U.S. EPA Region 5
Monitoring Diagram
Showing "Proposed Site"
Clinton LF, Dewitt Co. IL
By S.M. Johnson TSCA 3/23/2010

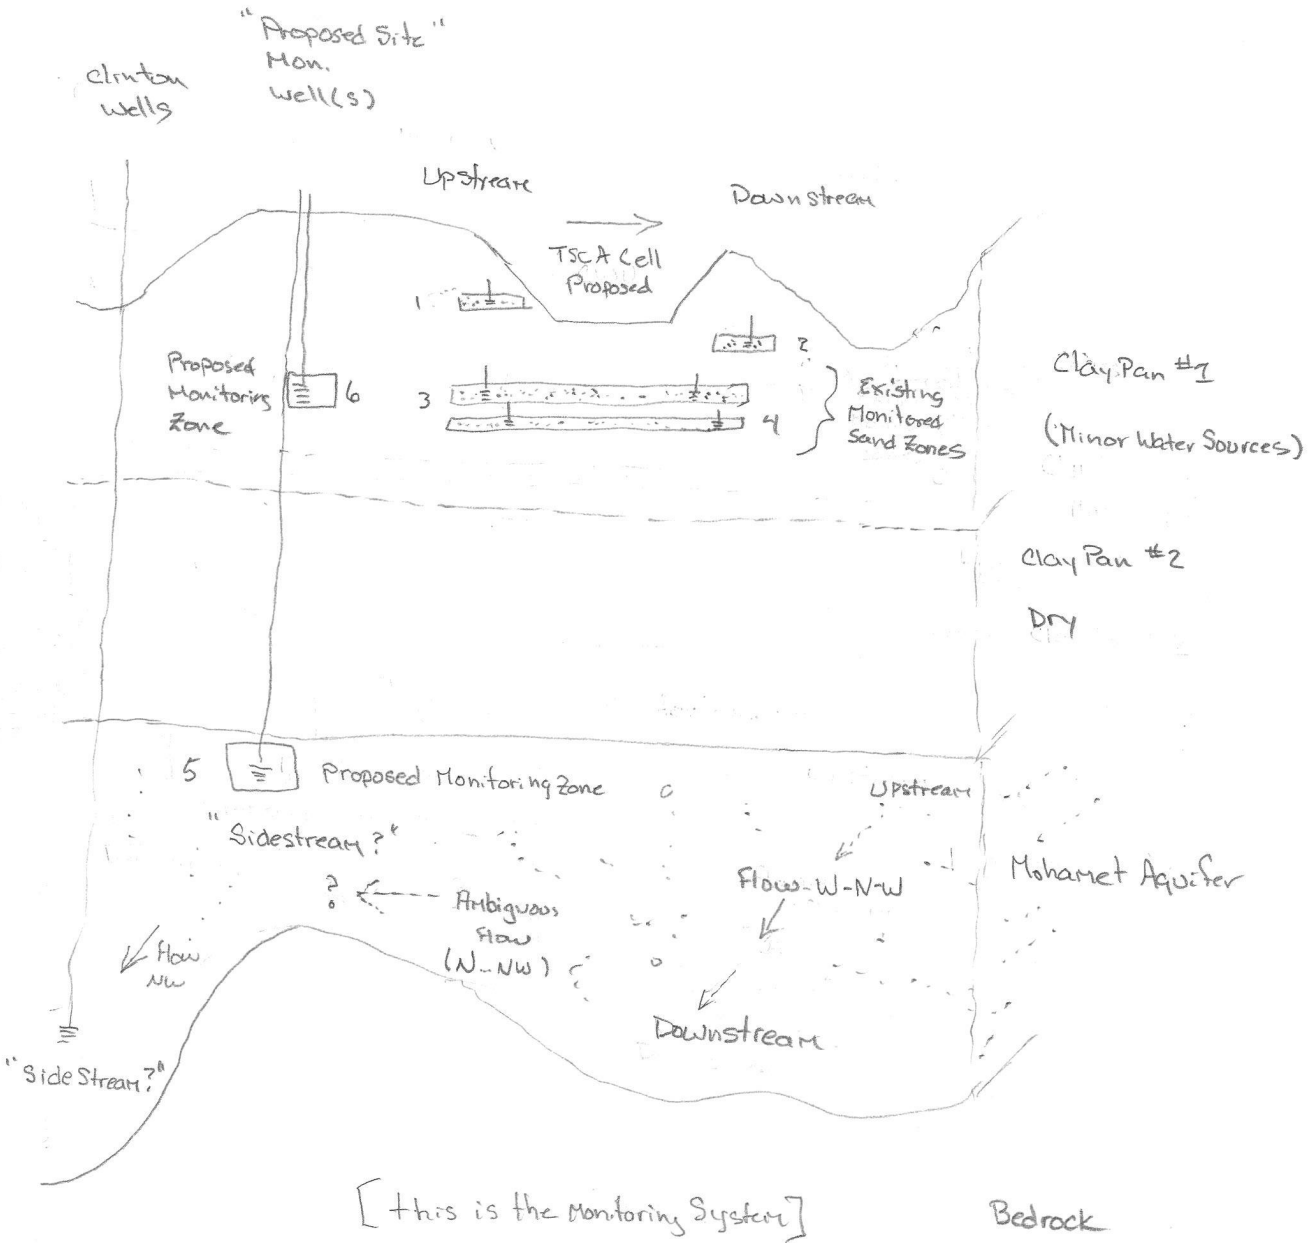
Note: Proposed Site has V. Limited ability to resolve questions - i.e.

- Question 1. Which way is Flow?
2. Why no upstream monitoring?
 3. What added Value would come?
 4. What is risk of whole new program?
 5. and do we have to waive requirements for Monitoring?
